## **Objection submission in response to SSD 81890707 (the SSDA) at 10, 14, 14A Stanhope Road Killara**

Department of Planning, Housing and Infrastructure  
Locked Bag 5022  
Parramatta NSW 2124  
Attention: Adela Murimba

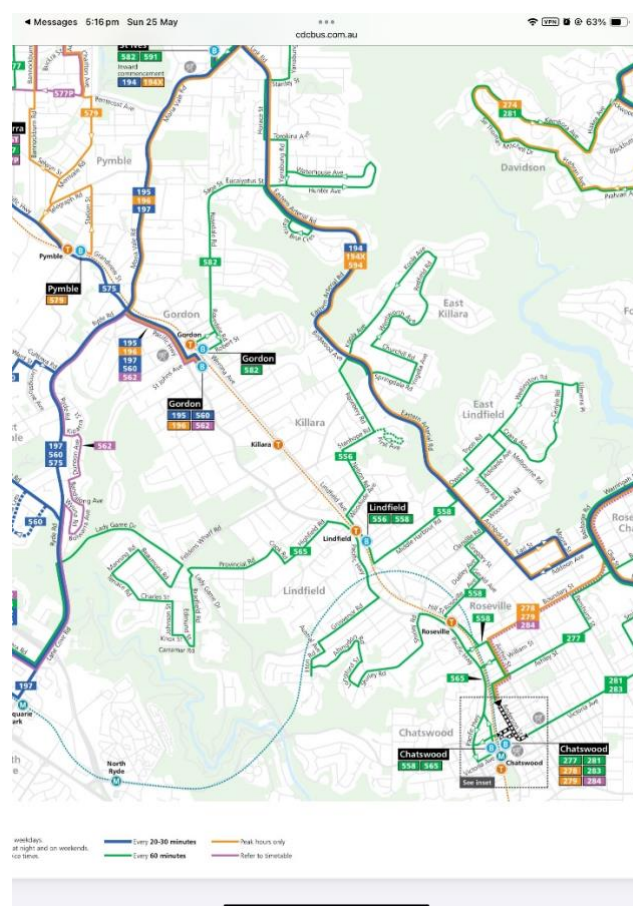
Impacts related to local character and sense of place have been assessed as Low Negative.

Response: this is grossly understated

#### Page 3 Impacts to amenities

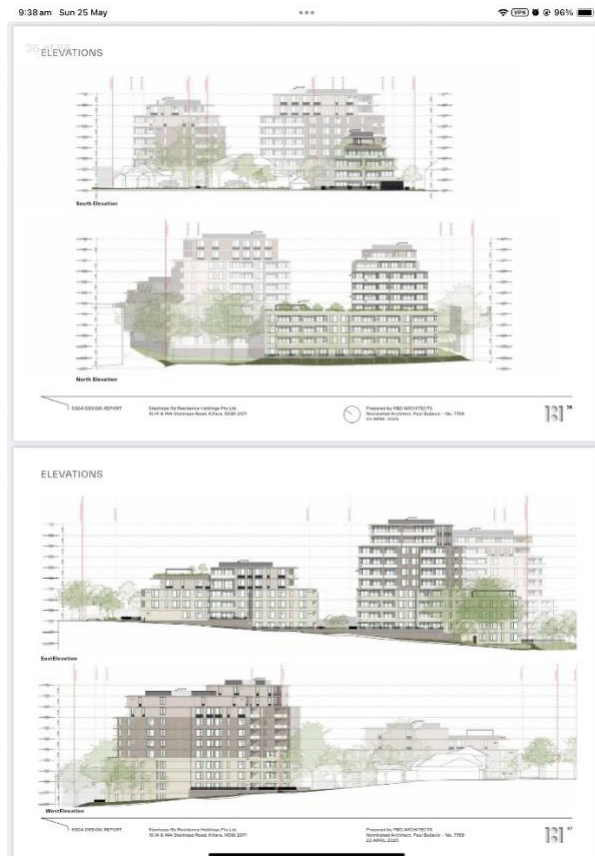
In some instances, local amenity can be adversely impacted by development. Loss of amenity can occur for a range of reasons, including significant increases to the heights of existing buildings, loss of heritage, more traffic, reduced parking, overshadowing and higher population density.

Response: Their own words. All apply.
